# DRAFT Engineering Report

## An Assessment of the Decision To Reject a Tunnel as a Viable Option to Replace the I-5 Bridge Over the Columbia River

January 2023

Figure 3. Columbia River Navigation Channels

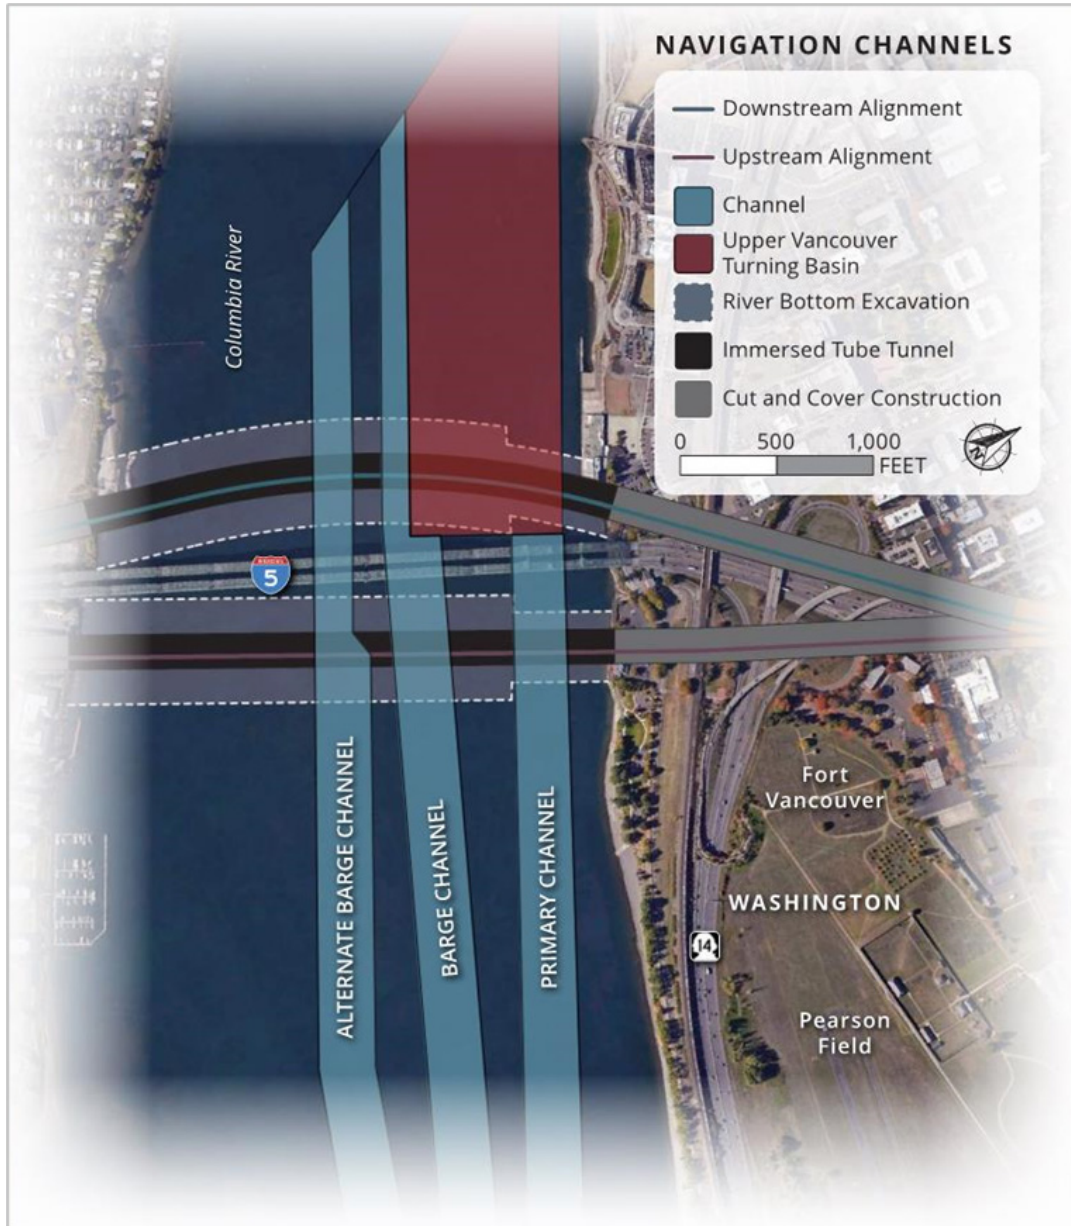
1. As shown on the attached Figure 3 from the Tunnel Concept Assessment, there are currently three navigation channels crossing the potential alignments of the tunnel, with the Primary Channel being located within close proximity to the north bank of the Columbia River under the lift-span

of the bridge. In addition, there are two barge channels located under the two highest spans of the existing bridge to the south.

3. If a tunnel were to be constructed, regardless of its depth, it is logical to assume that the three channels would be combined into a single 600-wide channel in the middle of the river. That 600-wide navigation channel is currently maintained through the entire length of the Columbia from its mouth to Vancouver, except at bridges, where several smaller channels are needed to avoid bridge piers. A credible conceptual tunnel design would have assumed that the channel would be relocated to the center of the river. Doing so would have put the low point of the tunnel near the center of the river instead of near the north bank. By sloping the tunnel up from the center of the river to the river banks, the tunnel would be much higher in elevation at its bank and inland. Instead of the tunnel being 90 feet deep at the bank as was assumed in the flawed DOT conceptual design, it would be about 45-feet deep.

Figure 4. Navigation Channel for the Downstream Alignment

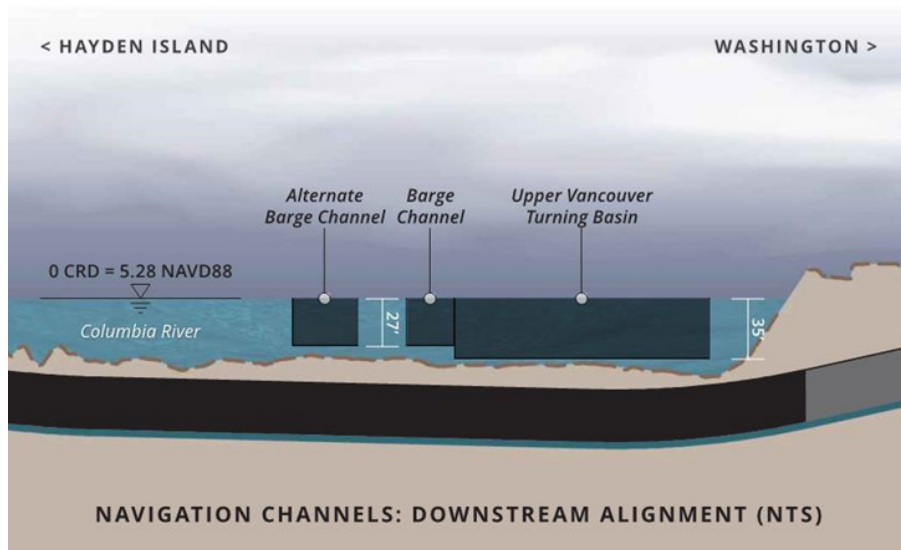
2. As shown on the attached Figure 4 from the Tunnel Concept Assessment, the low point of the tunnel was assumed to be below the Primary Channel near the north bank of the Columbia. Assuming that the Primary Channel would not be relocated, the low point of the tunnel is approximately 100 feet below the north bank of the river.

In short, by failing to make the logical assumption that the Primary Channel would be relocated to the center of the river, the tunnel was conceptually designed to be much deeper than necessary where it touches upon land on both sides of the river. In essence, this was a “tunnel too low” error.
